STARBUCKS COFFEE COMPANY
PORTION OF PARCEL I-A, TRACT BB
MONARCH VILLAGE CONT 0.5785 ACRES
CITY OF ALBUQUERQUE, COUNTY OF BERNALILLO, STATE OF NEW MEXICO
SITE CONSTRUCTION PLAN

SHEET TITLE:
GRADING DETAILS
AS-BUILT
SHEET NUMBER:
C390

SHEET TITLE:
GRADING & DRAINAGE PLAN
AS-BUILT
SHEET NUMBER:
C301

**RE: Starbucks
700 Juan Tabo Blvd. NE
Grading and Drainage Plan
Engineers Stamp Date 3/12/15 (K22D006B)
Certification Dated 10/19/15**

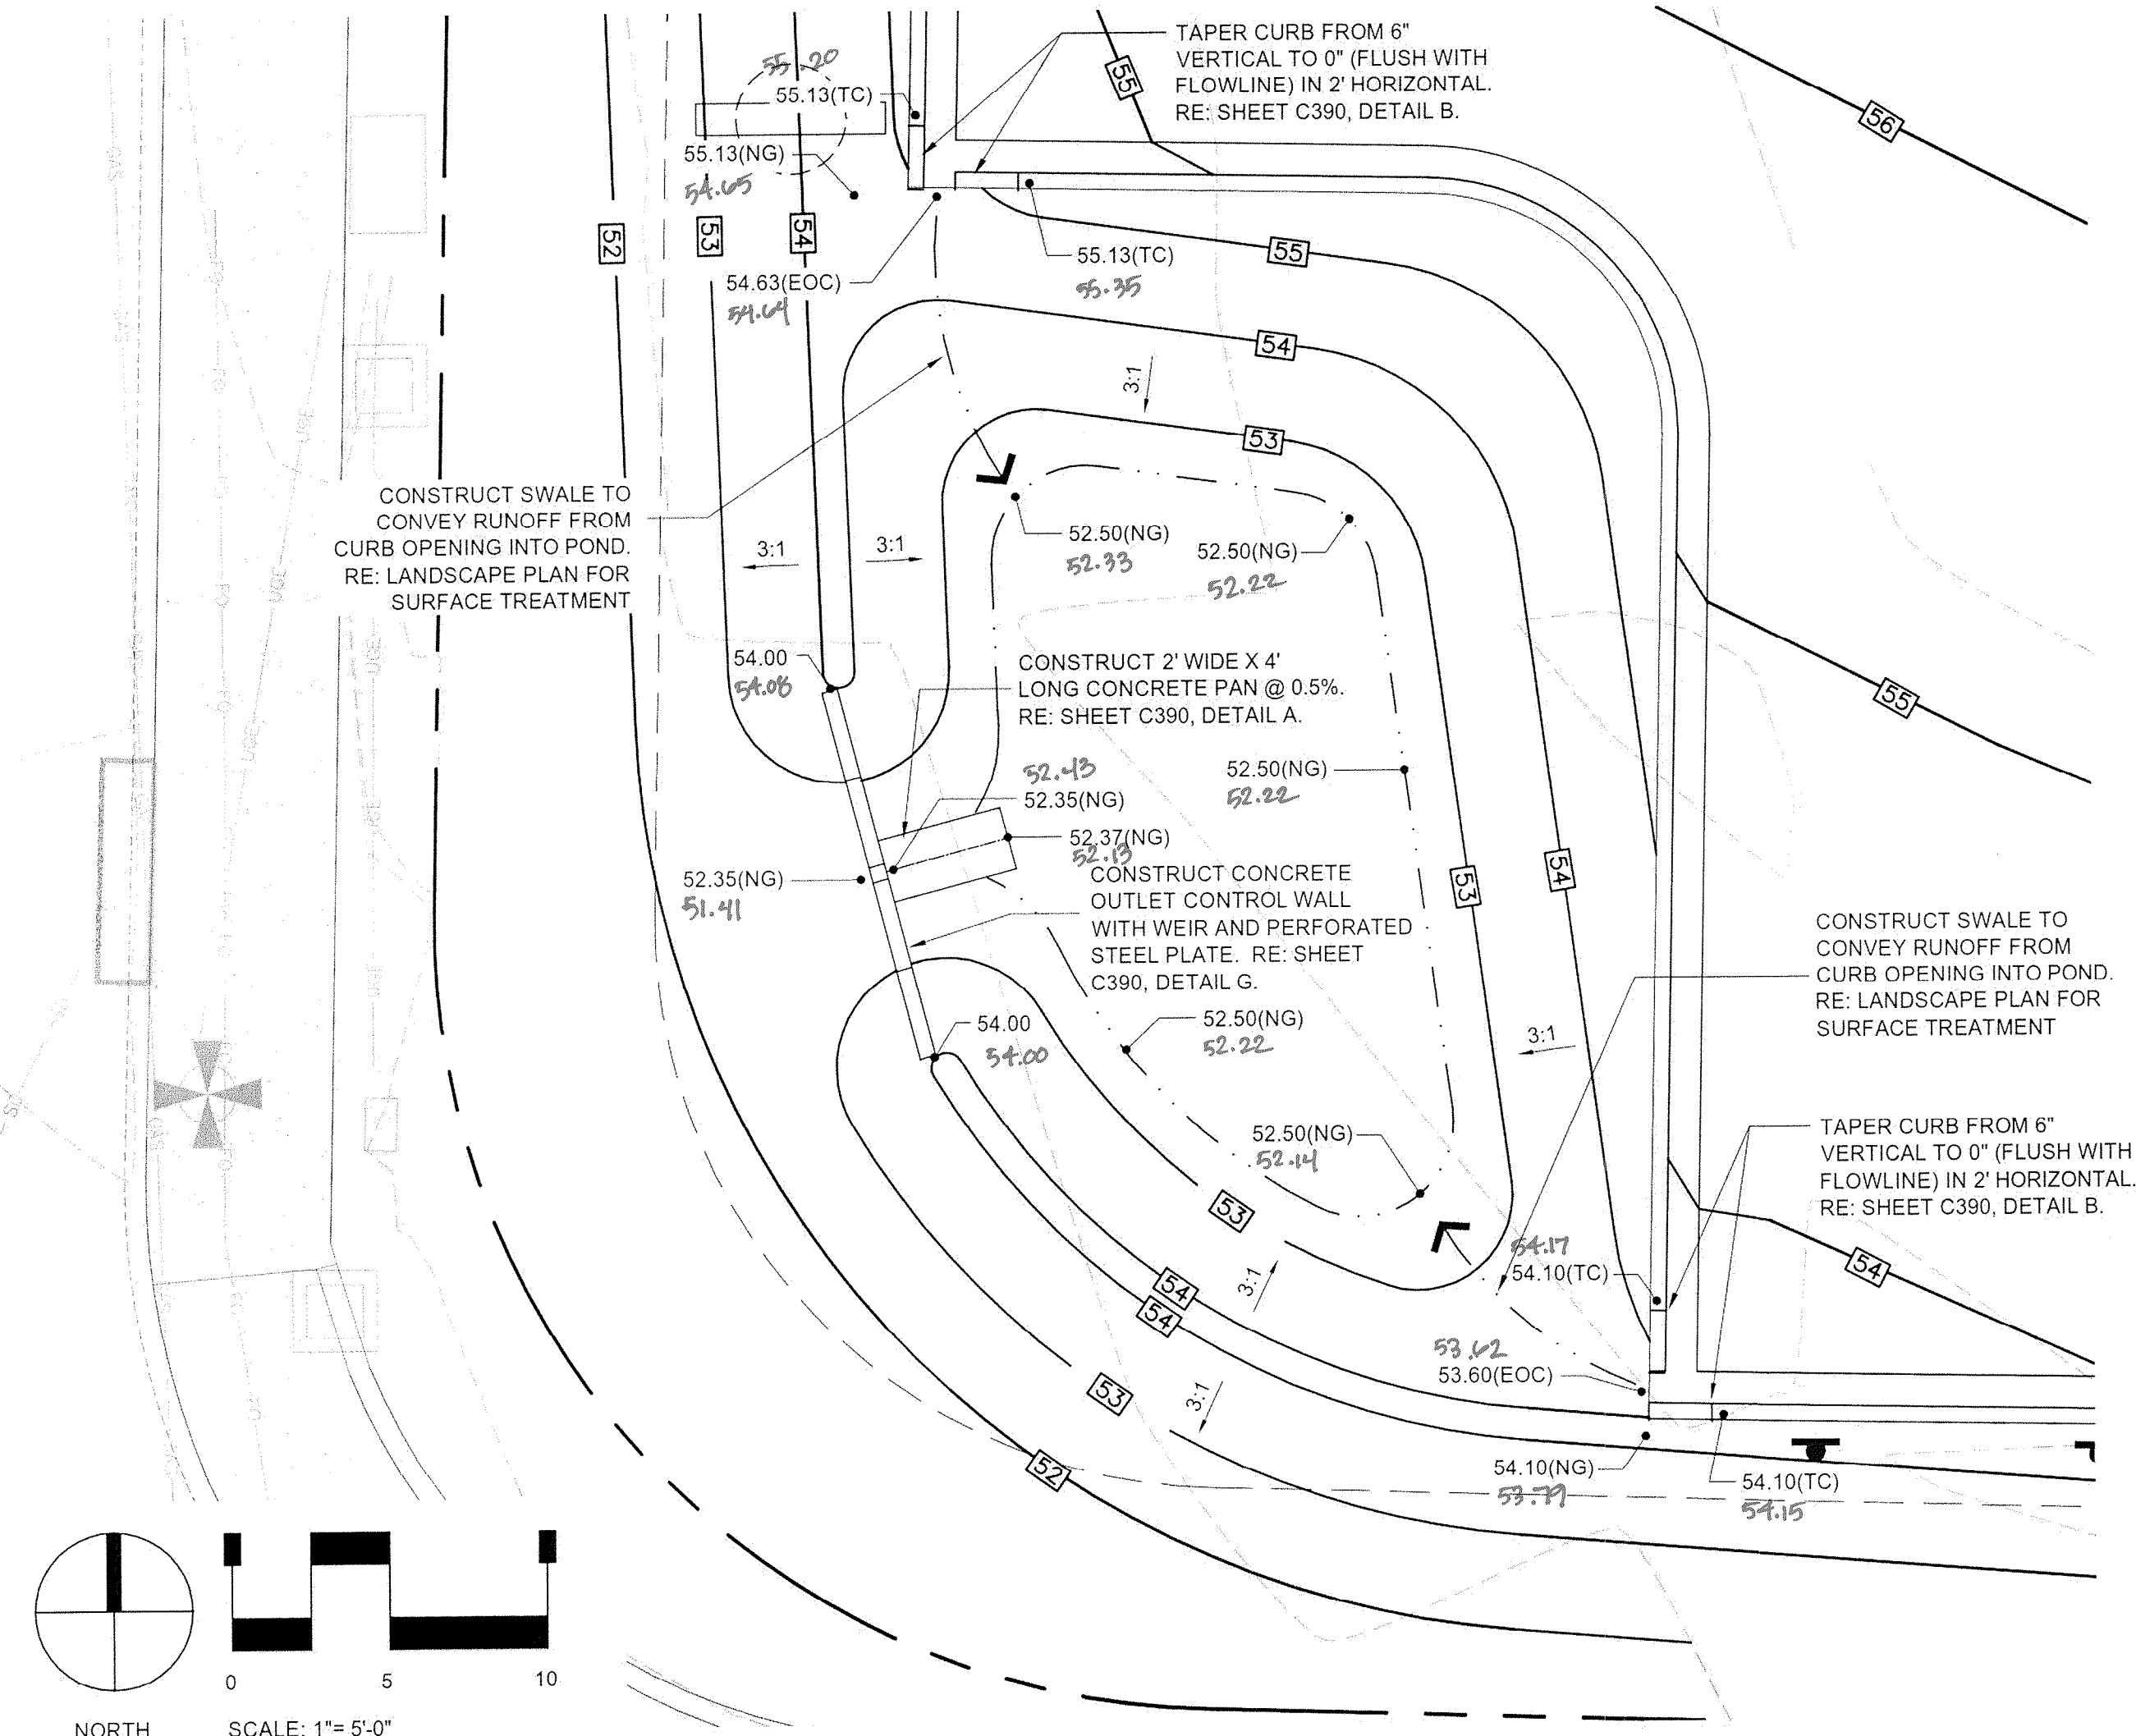
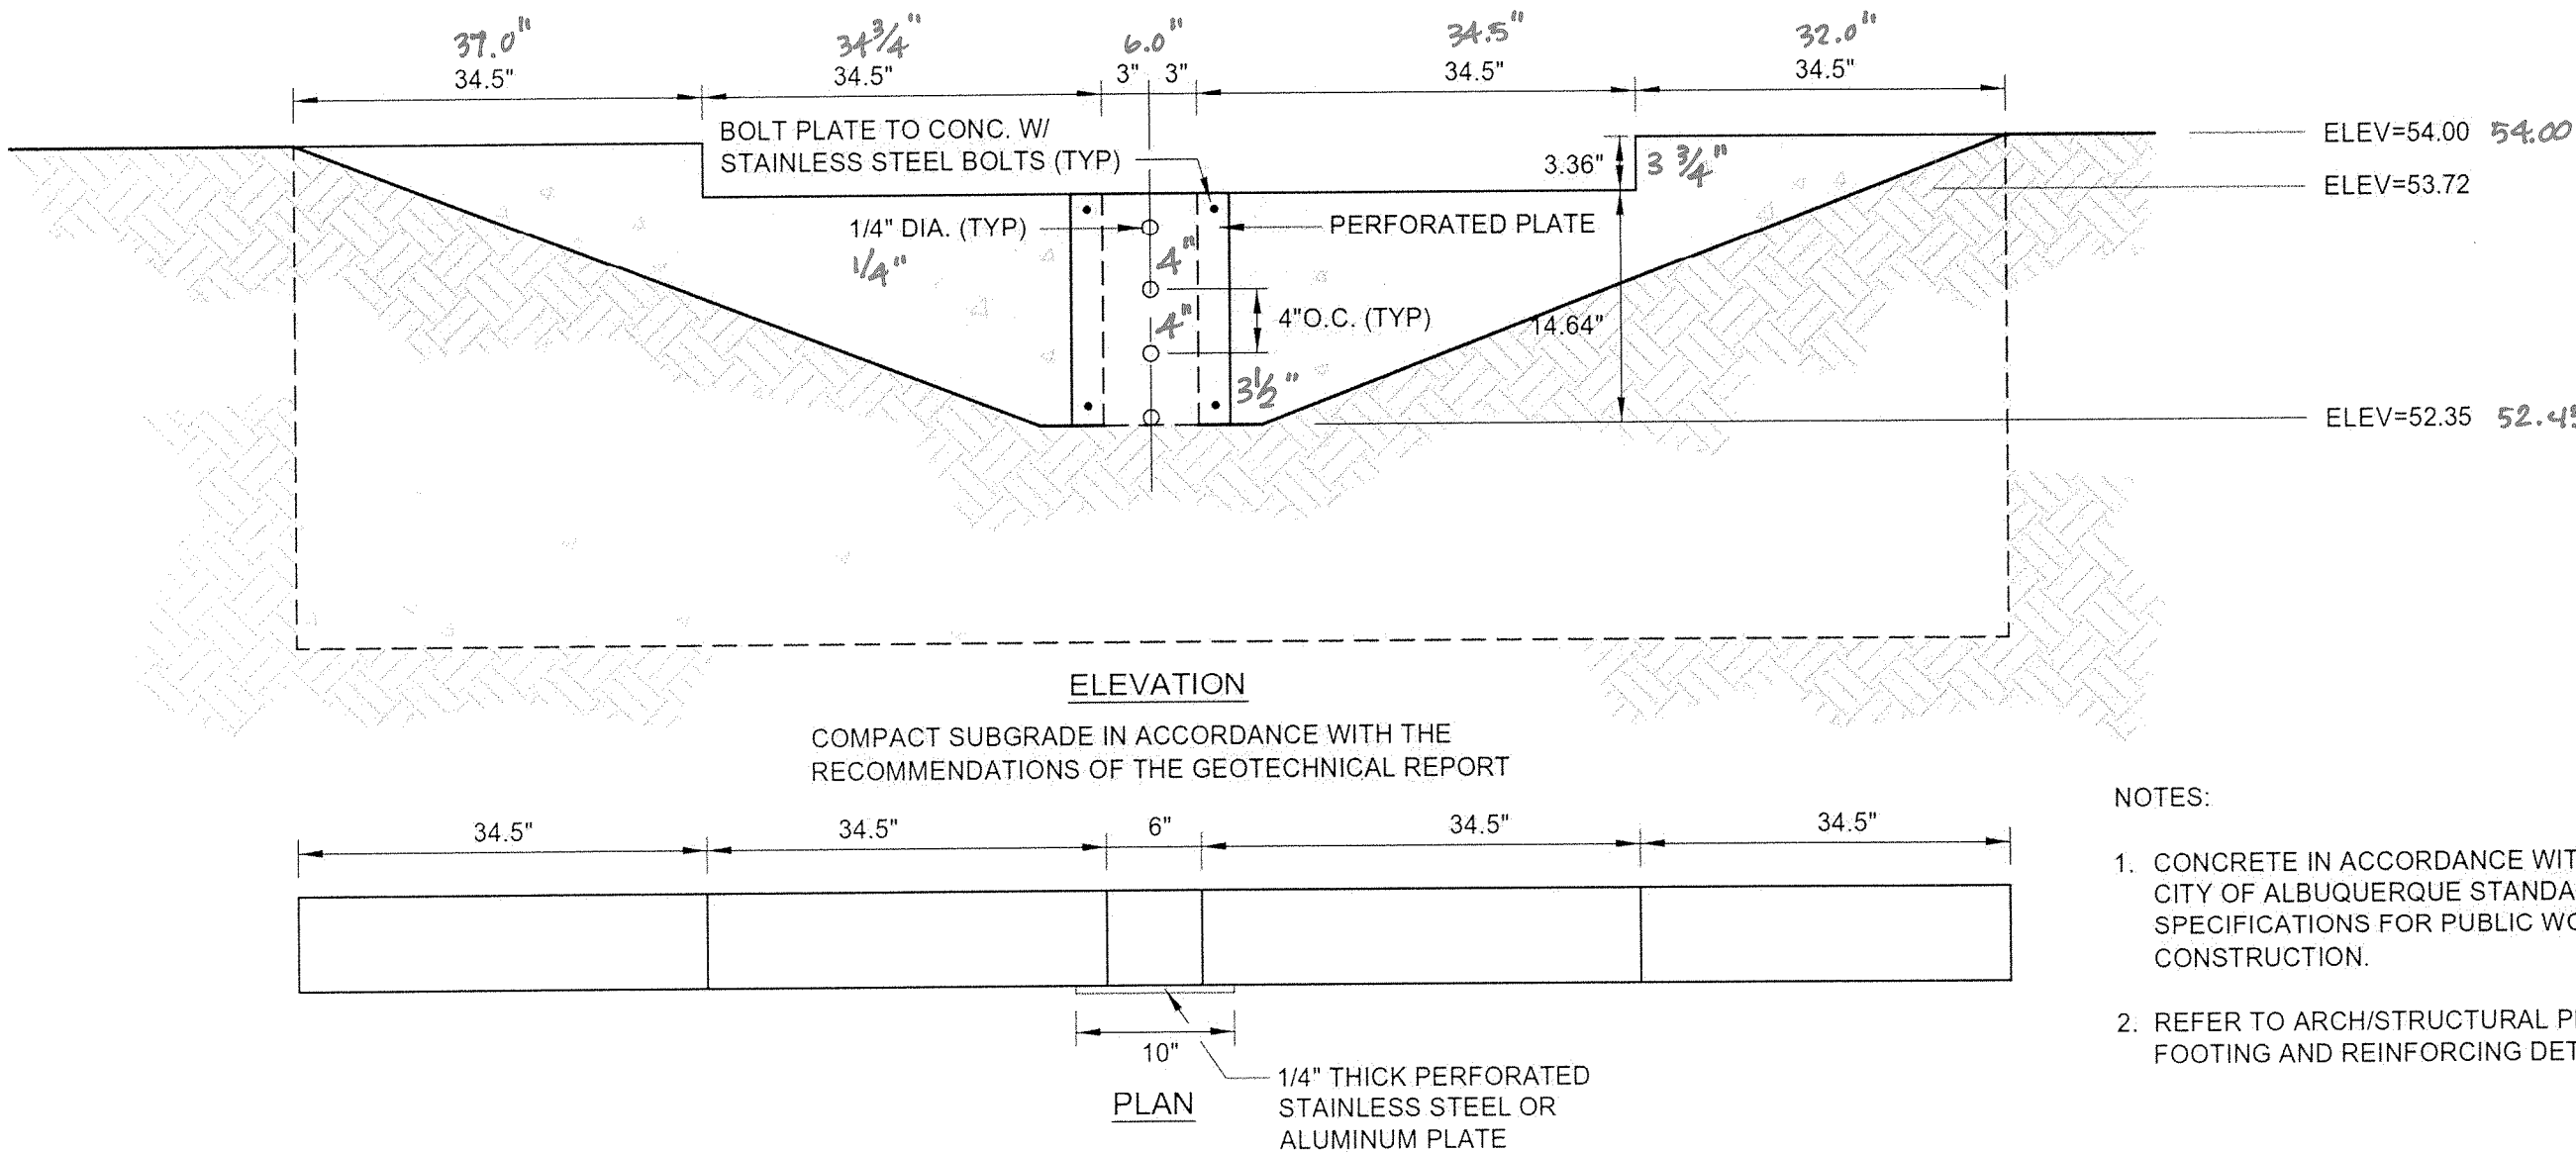
AS-BUILT INFORMATION AS SHOWN
PROVIDED BY NM REGISTERED LAND
SURVEYOR THOMAS D. JOHNSTON, #14269

Upon review it has been found that the 2-foot wide concrete pan on the east side of the building conveys runoff entirely to the south rather than portions to the south and portions to the north. Portions of the pan are also constructed with a flat slope. The finished grade elevations of and near the trash enclosure suggest portions of the adjacent drive aisle may contribute minor runoff to the enclosure. The pond elevations indicate a lower pond bottom and a lower pond weir than described on the approved plans; however, calculations indicate provision of the design volume. In addition and as approved by the city, the ATM that previously existed at the southeast corner of the site has been removed. These and other deviations from the grading and drainage design described on the approved plan(s) represent discrepancies which are minor in nature and/or should impact maintenance of the property rather than the overall drainage design intent.

Based on the review described herein, of the information listed herein, and of this information only, it appears the improvements associated with the grading and drainage aspects of the project have been graded and will drain in substantial compliance with the overall design intent of the approved plan(s).

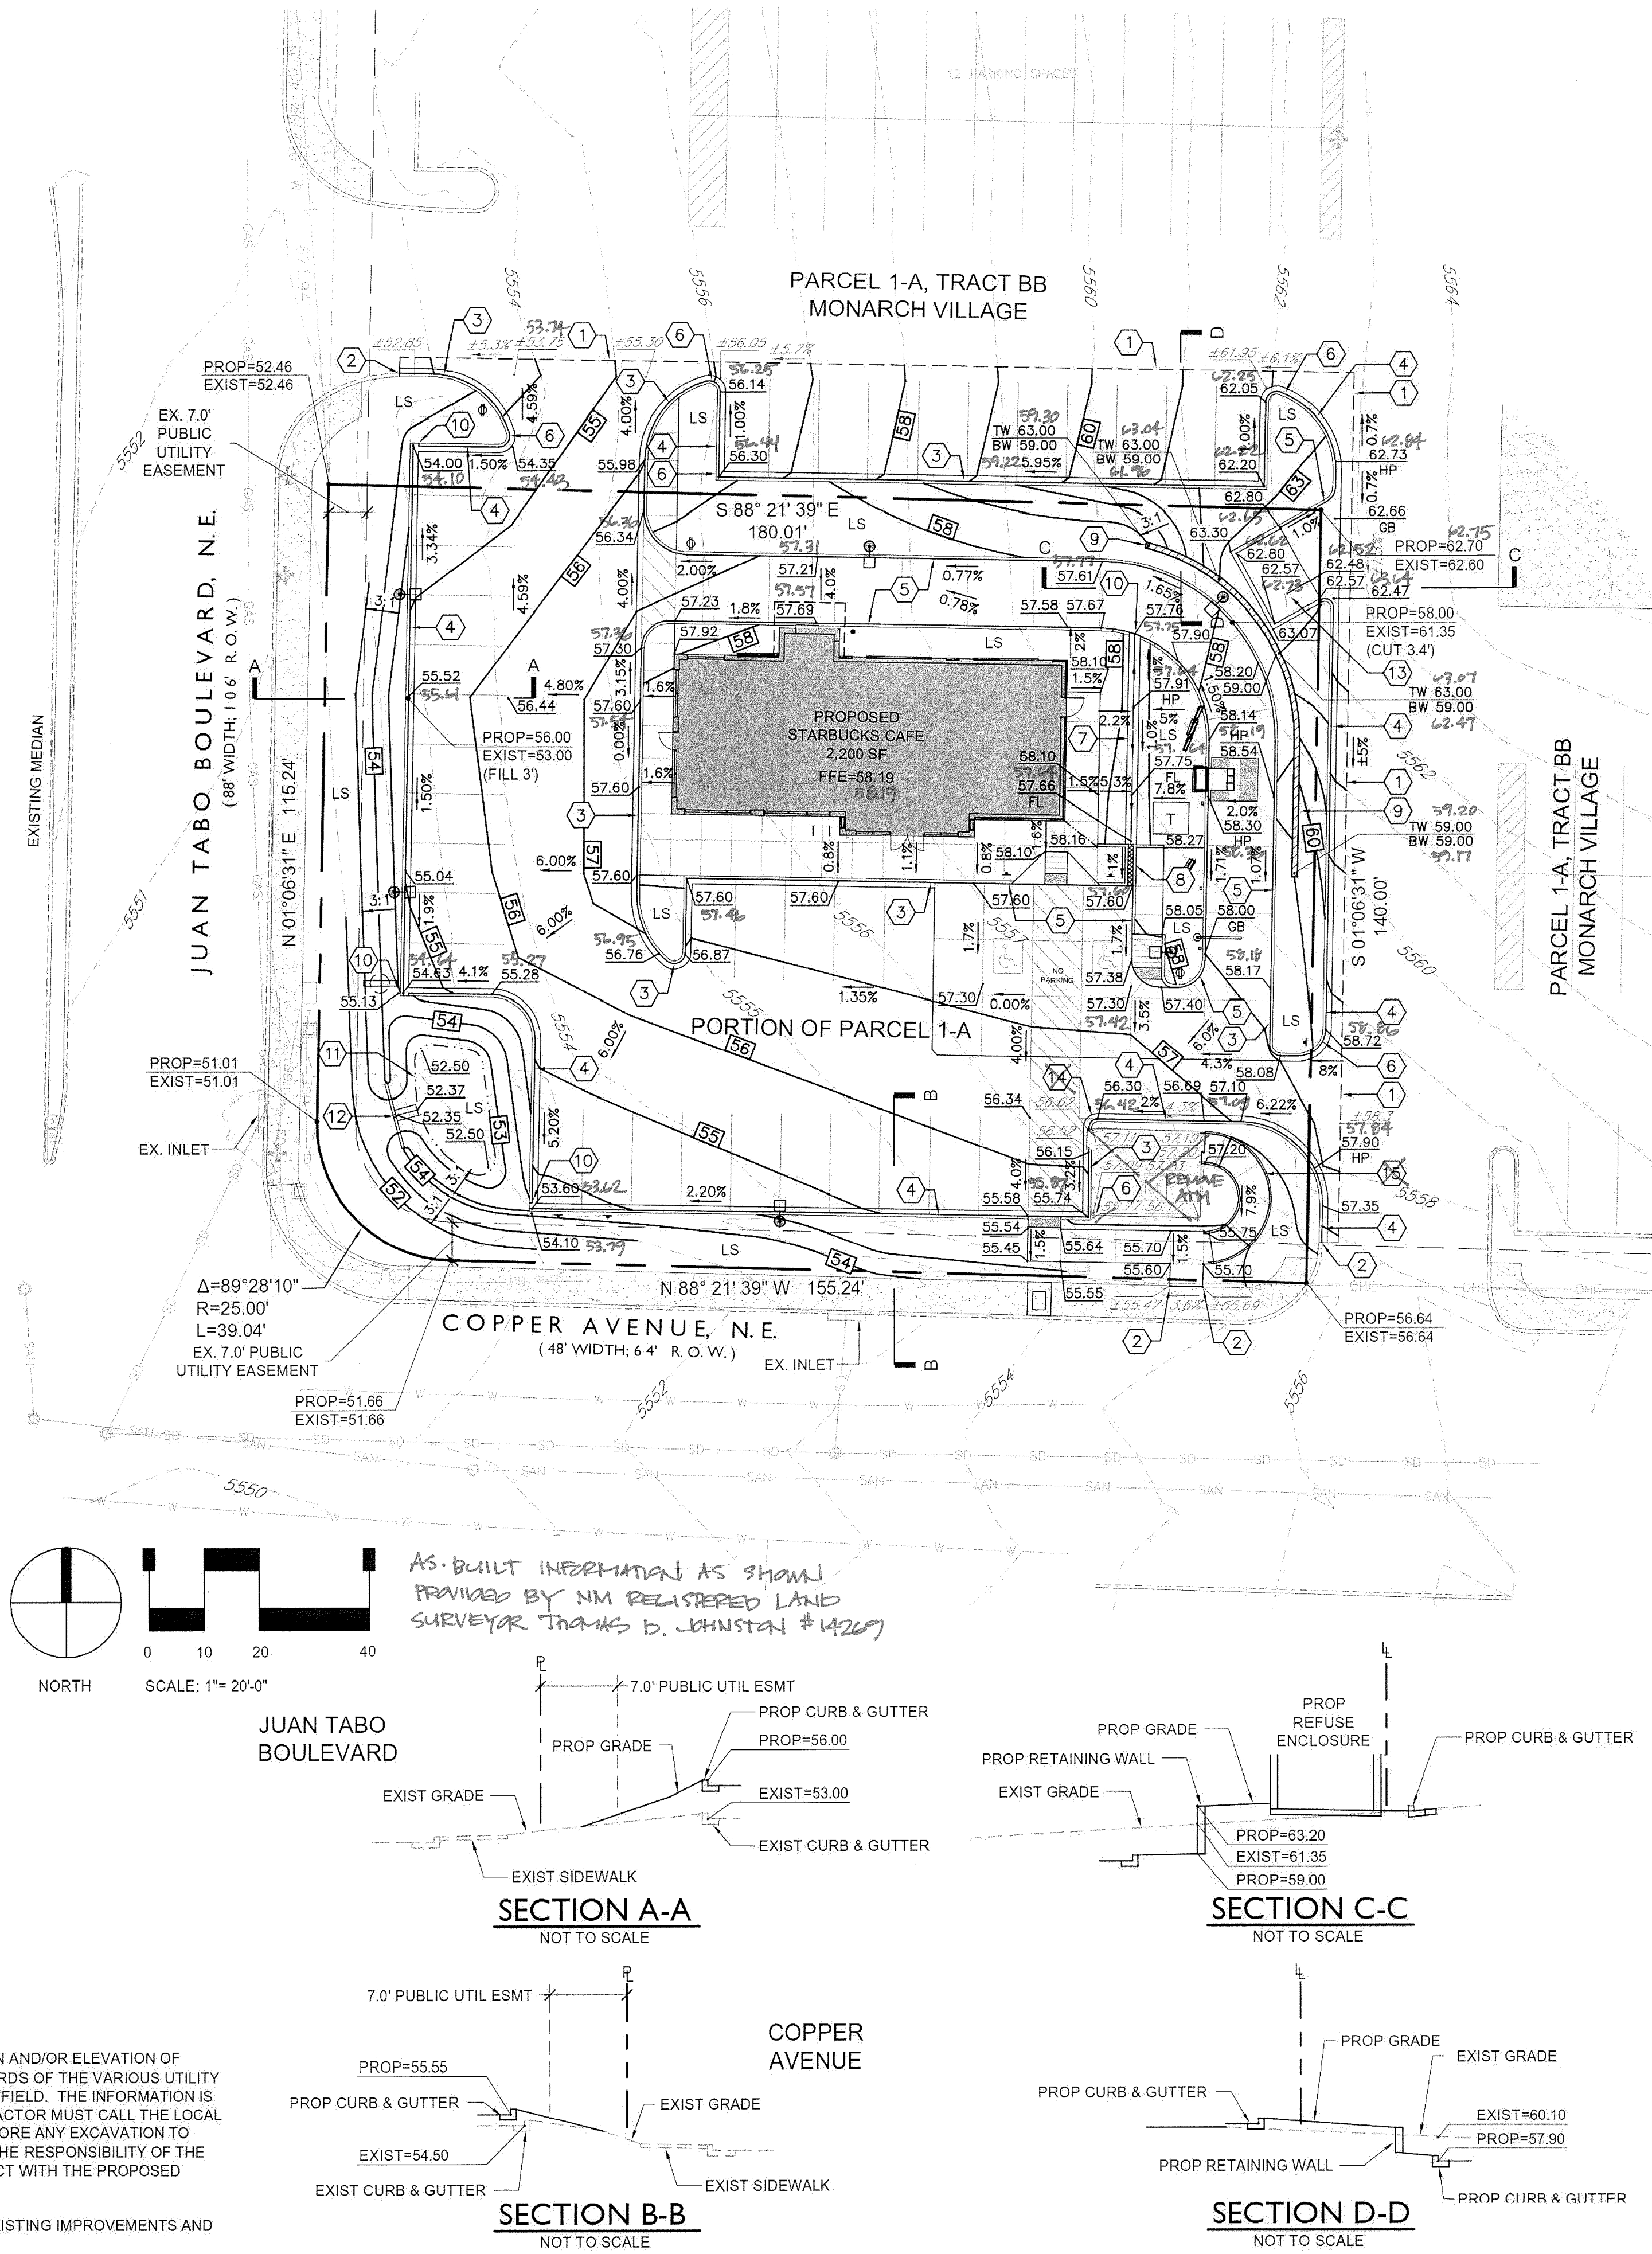
Upon review it has been found that the 2-foot wide concrete pan on the east side of the building conveys runoff entirely to the south rather than portions to the south and portions to the north. Portions of the pan are also constructed with a flat slope. The finished grade elevations of and near the trash enclosure suggest portions of the adjacent drive aisle may contribute minor runoff to the enclosure. The pond elevations indicate a lower pond bottom and a lower pond weir than described on the approved plans; however, calculations indicate provision of the design volume. In addition and as approved by the city, the ATM that previously existed at the southeast corner of the site has been removed. These and other deviations from the grading and drainage design described on the approved plan(s) represent discrepancies which are minor in nature and/or should impact maintenance of the property rather than the overall drainage design intent.

Based on the review described herein, of the information listed herein, and of this information only, it appears the improvements associated with the grading and drainage aspects of the project have been graded and will drain in substantial compliance with the overall design intent of the approved plan(s).
